**Re: Pio Pico Energy Center Project (11-AFC-01)  
Worker Safety and Fire Protection Supplemental Information**

Plot Plan

08/22/11  
LAD DWG C. FERROVALLI  
P100-041-PP-004

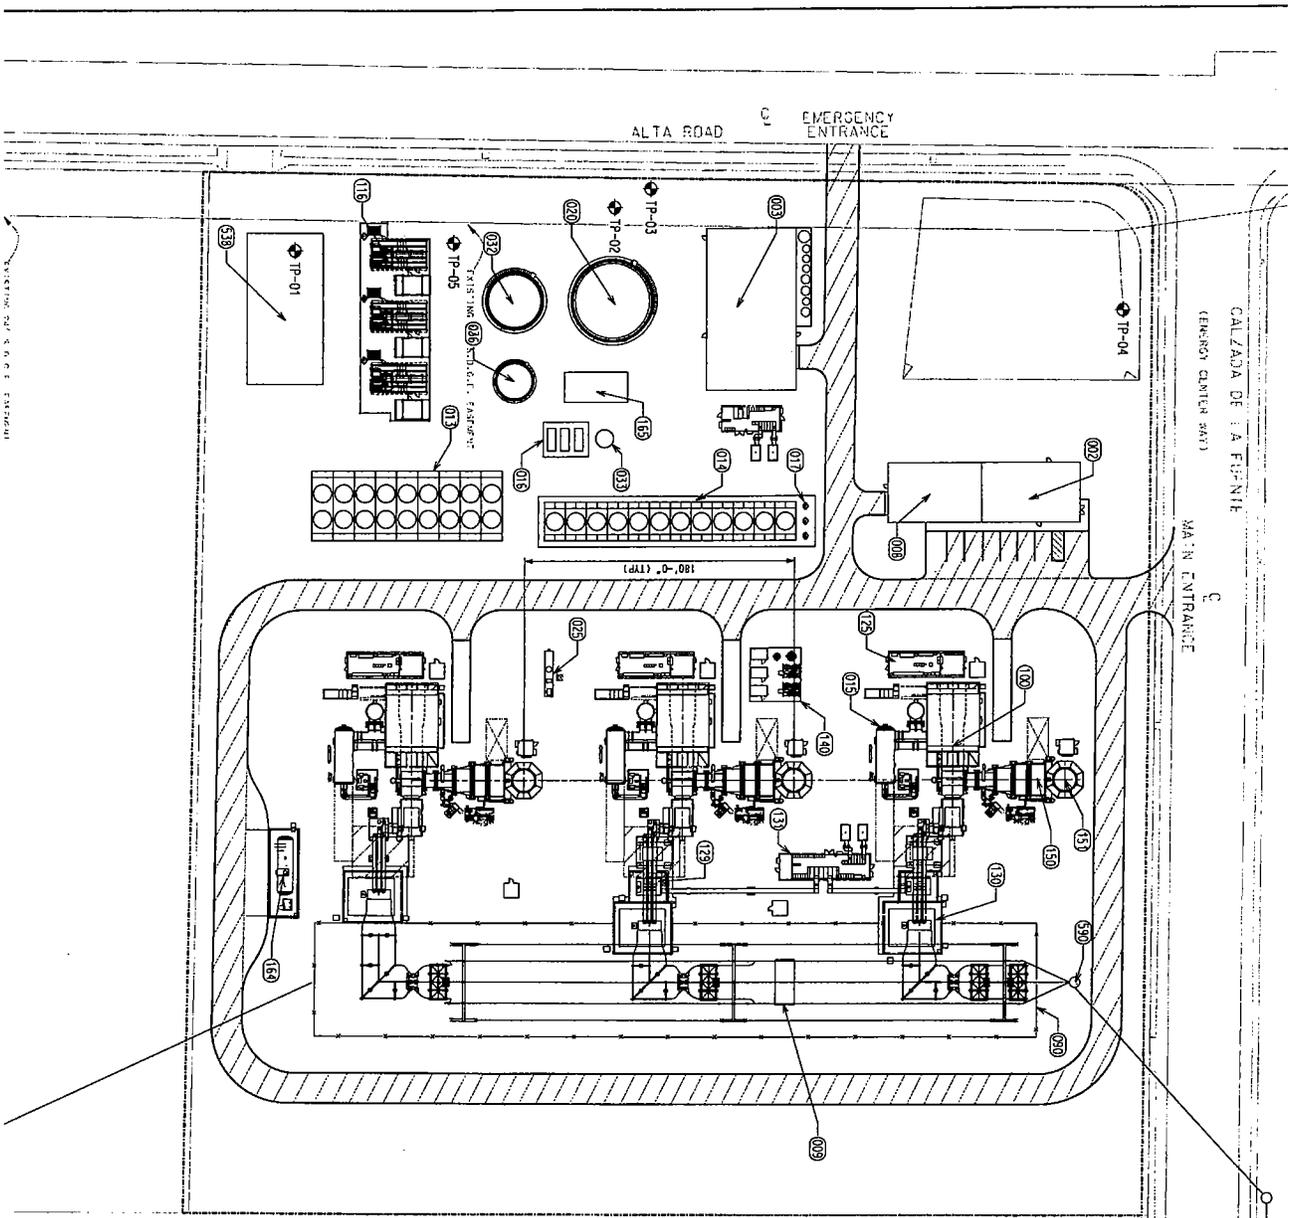
I have reviewed attached site plan, the Fire District is OK with proposed access location as well.

We are okay with the proposed "rolled curb" emergency entrance in this location.

Attached is an update of the Pio Pico Plot Plan showing the proposed Emergency Entrance location off Alta Road. This is just to show the proposed location based on recent discussions and not the design details. Please advise if there are any comments or questions.
